Facility Name: South Texas DeWatering Facility

RE: South Texas Dewatering Facility - MSW Permit No. 2417 Tracking No. 28154406

On behalf of South Texas Dewatering, INTERA Incorporated (INTERA) is submitting supplemental information regarding the Type V permit application for the South Texas Dewatering Facility in Alice. The enclosed documents reflect the addition of a roof over the Unloading Area.

TCEQ MSW Type V Permit Application

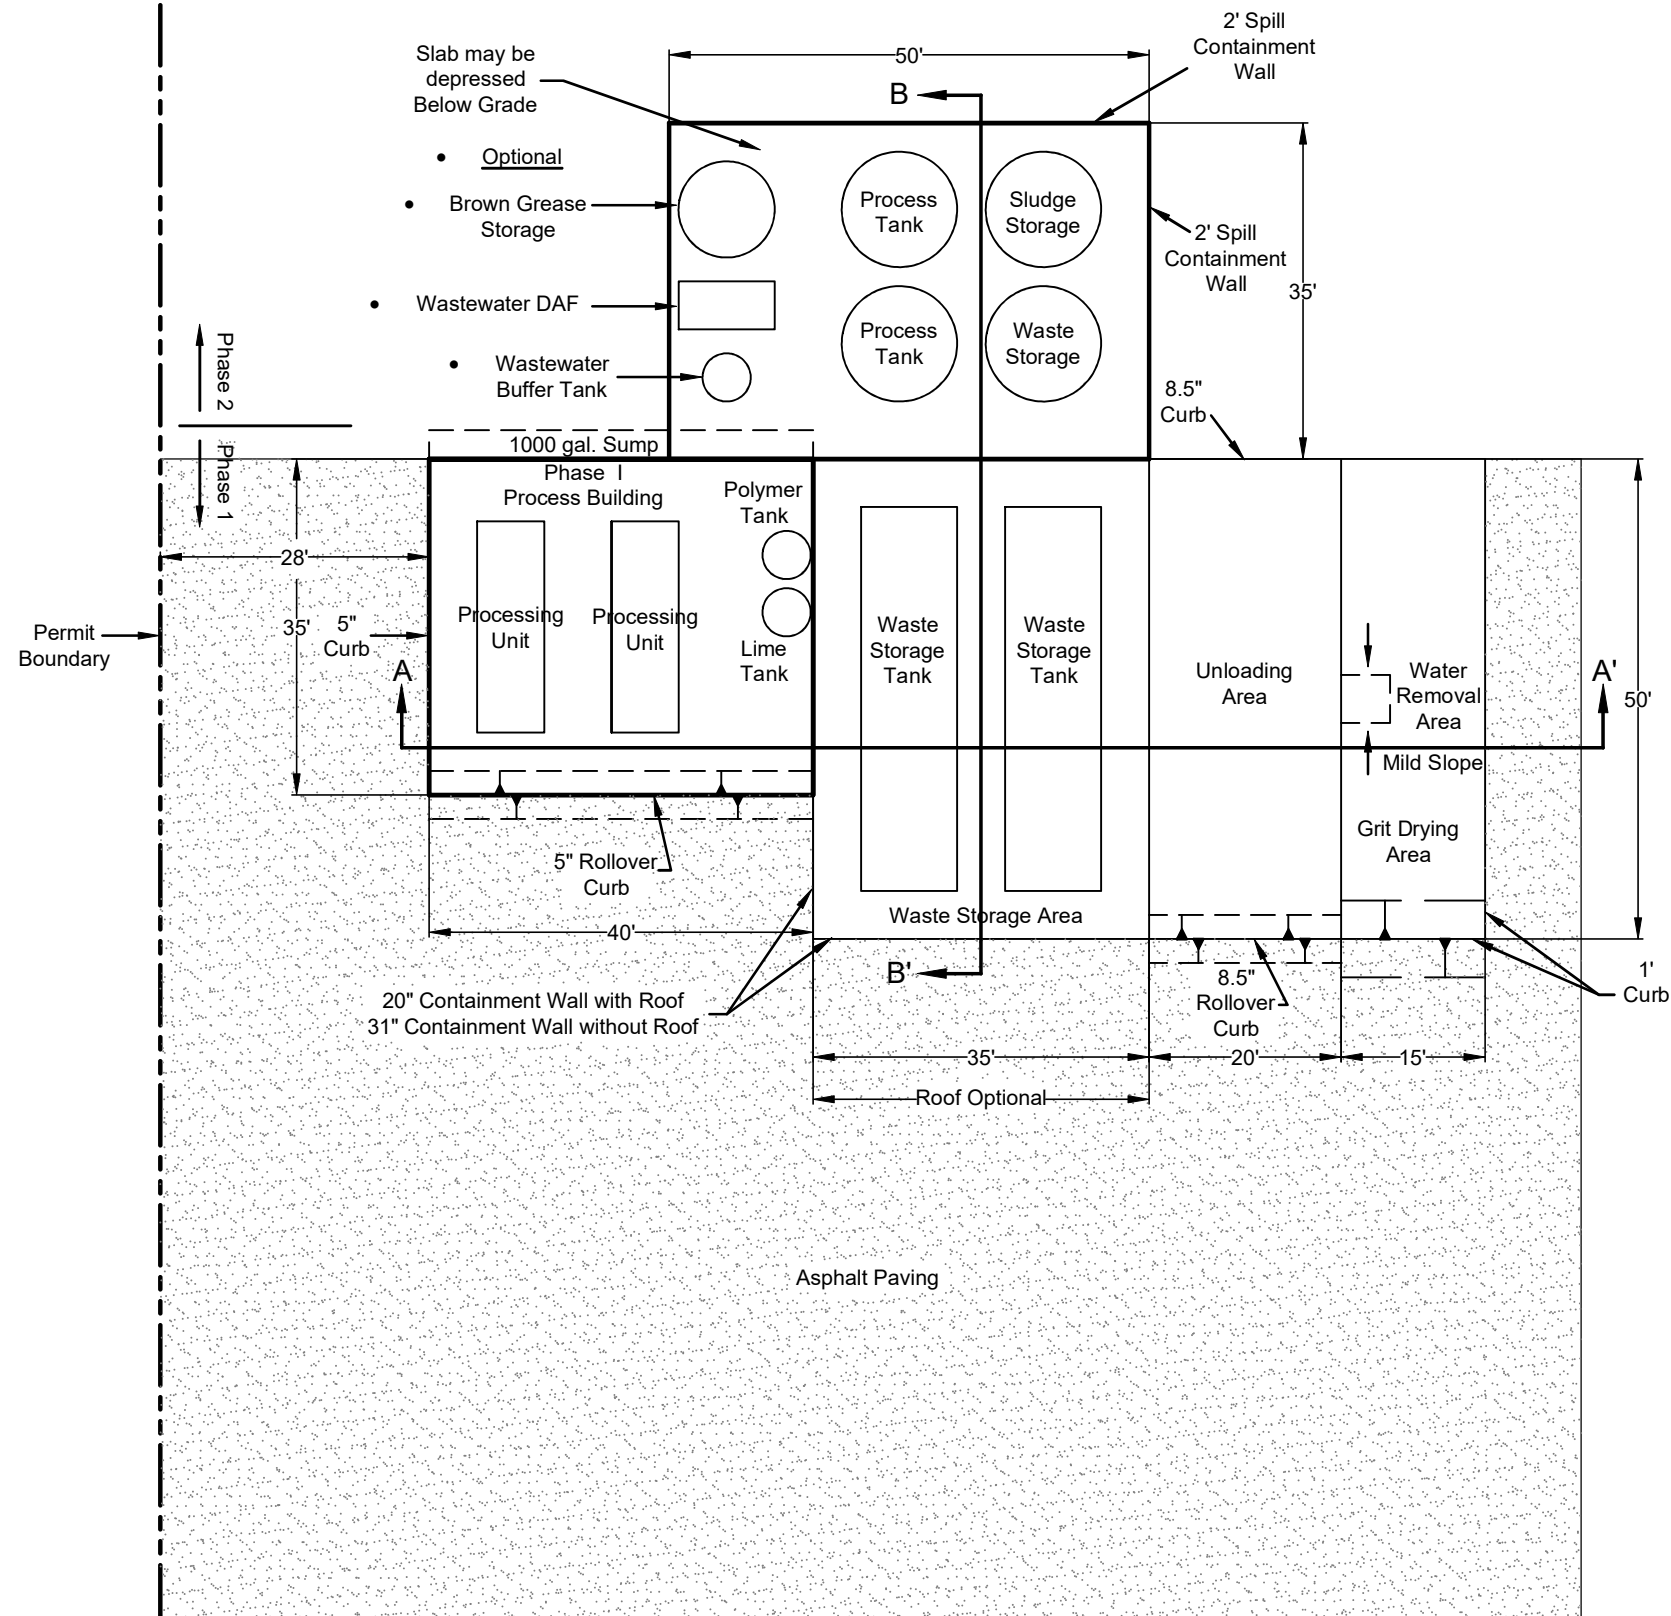
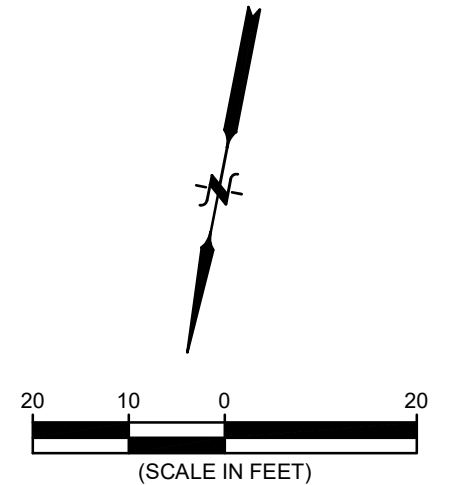
Unloading Area -- Truck unloading of incoming liquid waste will occur at the paved unloading slab, which incorporates minimum 8.5 inch rollover curbs or walls to control runoff and also contain waste spills. This area will be roofed and can store a 5,000 gallon spill from a tanker truck. Containment calculations are shown in Appendix 4.

2	8/07/23	ADDED UNLOADING AREA ROOF		
1	7/12/23	PER TECHNICAL NOD2		
REV.	DATE	DESCRIPTION	DR BY	APP BY
 INTERA 9600 GREAT HILLS TRAIL, SUITE 300W AUSTIN, TEXAS 78759 USA 512-425-2000 TEXAS REGISTERED ENGINEERING FIRM F-4722				
PROJECT: SOUTH TEXAS DEWATERING 502 COMMERCE ROAD ALICE, TEXAS				
SHEET TITLE: OPERATIONS AREA DETAIL				
DES BY			SCALE: SEE BAR SCALE	
DR BY	SDB		PROJ NO. STXWWW.M001.MSW	
CHK BY	JBD		DWG NO. STXWWW.M001.MSW010R2	
APP BY	JJG		SHEET 1 OF 1 SHEETS	
DATE ISSUED: 12-12-2022			FIGURE NO.	
PURPOSE: PERMIT APPLICATION			10

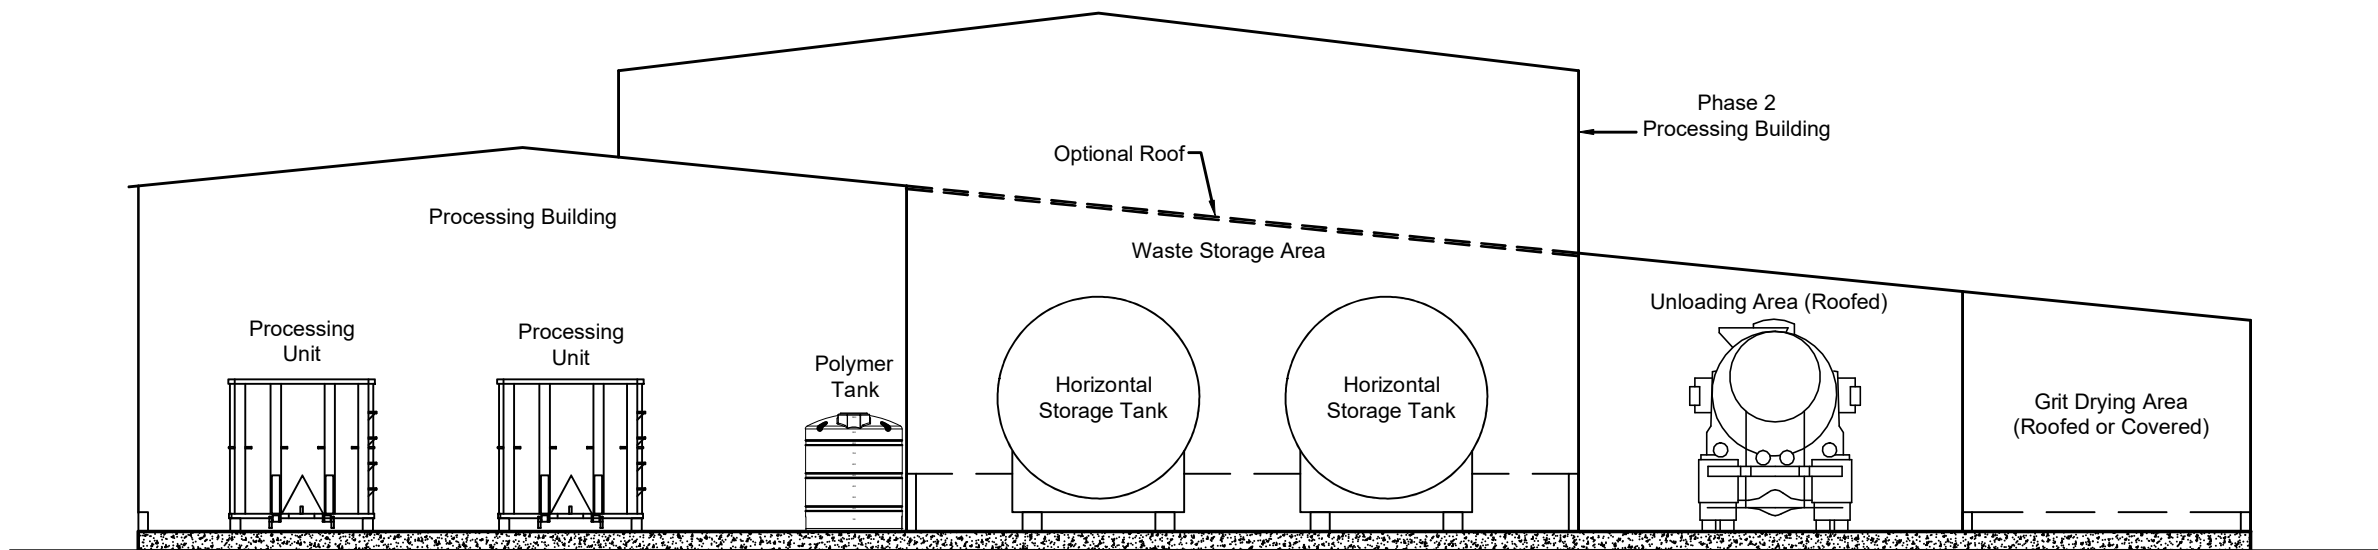
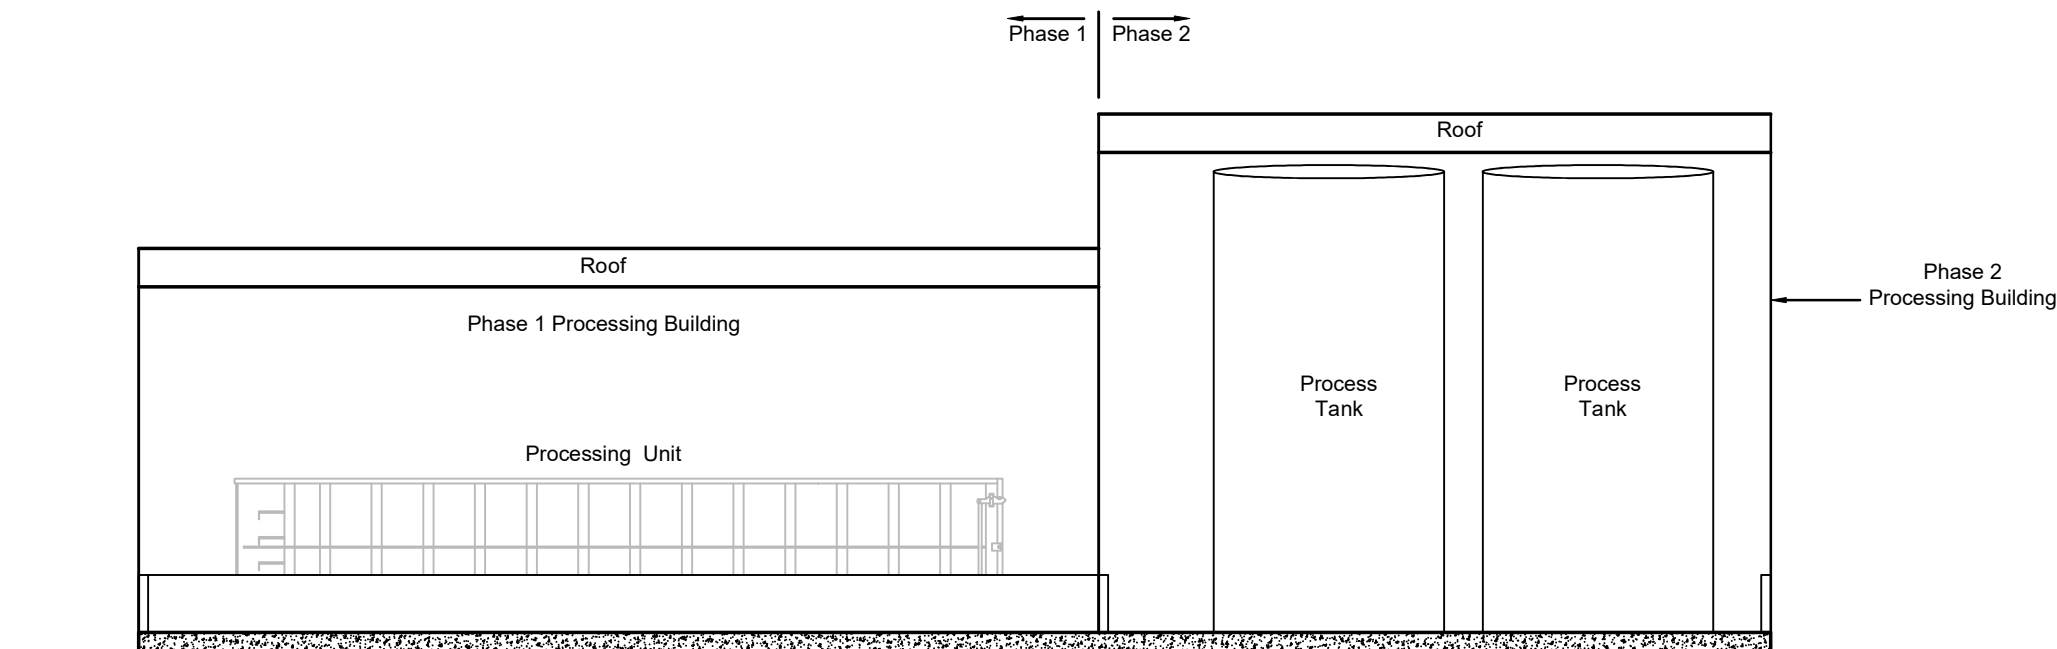
2	8/07/23	ADDED UNLOADING AREA ROOF		
1	7/12/23	PER TECHNICAL NOD2		
REV.	DATE	DESCRIPTION	DR BY	APP BY
<div><div>INTERA</div><div>9600 GREAT HILLS TRAIL, SUITE 300W AUSTIN, TEXAS 78759 USA 512-425-2000 TEXAS REGISTERED ENGINEERING FIRM F-4722</div></div>				
PROJECT: SOUTH TEXAS DEWATERING 502 COMMERCE ROAD ALICE, TEXAS				
SHEET TITLE: OPERATIONS AREA CROSS SECTIONS				
DES BY		SCALE:	SEE BAR SCALE	
DR BY	SDB	PROJ NO.	STXWWW.M001.MSW	
CHK BY	JBD	DWG NO.	STXWWW.M001.MSW011R2	
APP BY	JJG	SHEET	1 OF 1 SHEETS	
DATE ISSUED: 12-12-2022		FIGURE NO.		
PURPOSE: PERMIT APPLICATION		11

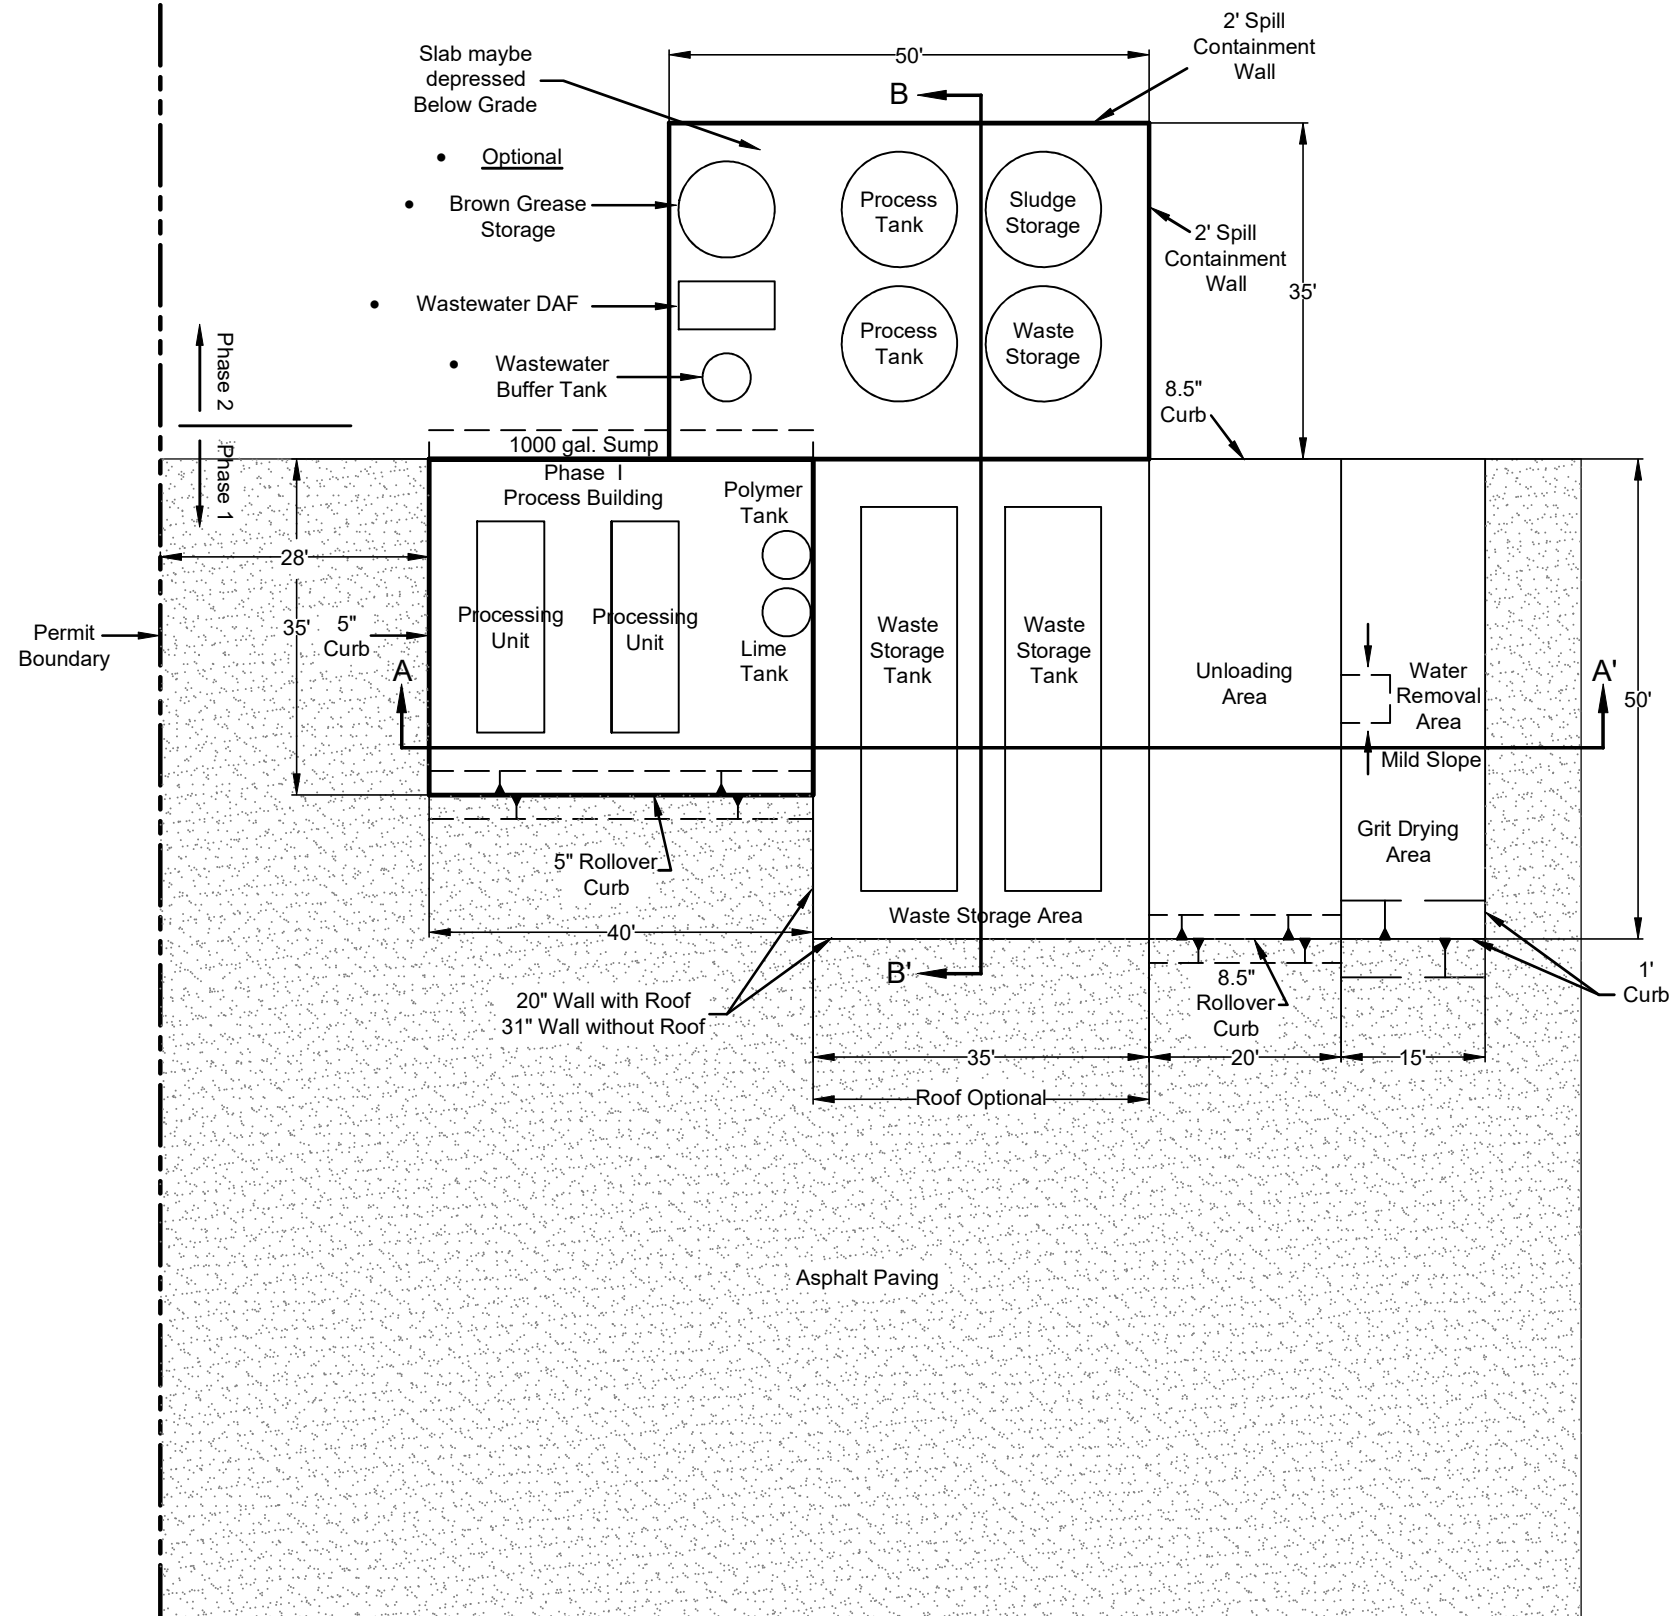
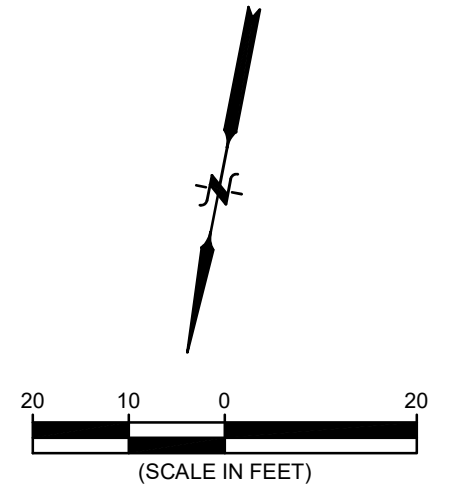
The Unloading Area is composed of a truck unloading area and is designed to contain a spill from a 5,000 gallon truck. A low 0.7 ft (8.5 inch) rollover curb is provided on the north and south sides of the unloading area and short walls on the other sides. This area will be roofed.

2	8/07/23	ADDED UNLOADING AREA ROOF		
1	7/12/23	PER TECHNICAL NOD2		
REV.	DATE	DESCRIPTION	DR BY	APP BY
 INTERA 9600 GREAT HILLS TRAIL, SUITE 300W AUSTIN, TEXAS 78759 USA 512-425-2000 TEXAS REGISTERED ENGINEERING FIRM F-4722				
PROJECT: SOUTH TEXAS DEWATERING 502 COMMERCE ROAD ALICE, TEXAS				
SHEET TITLE: OPERATIONS AREA DETAIL				
DES BY			SCALE: SEE BAR SCALE	
DR BY	SDB		PROJ NO. STXWWW.M001.MSW	
CHK BY	JBD		DWG NO. STXWWW.M001.MSW015R2	
APP BY	JJG		SHEET 1 OF 1 SHEETS	
DATE ISSUED: 12-12-2022			FIGURE NO.	
PURPOSE: PERMIT APPLICATION			4-1

This area will be covered with a roof so the minimum required containment is equal to the capacity of the largest tank (5,000 gallon tanker truck).

Area	980 ft ²	(20 x 50 ft less 2 ft rollover ramp)
Storage depth h =	0.7 ft	
Volume Provided =	686 ft ³	
	5,131 gallons

Excess Containment Volume **With Roof** **131 gallons**
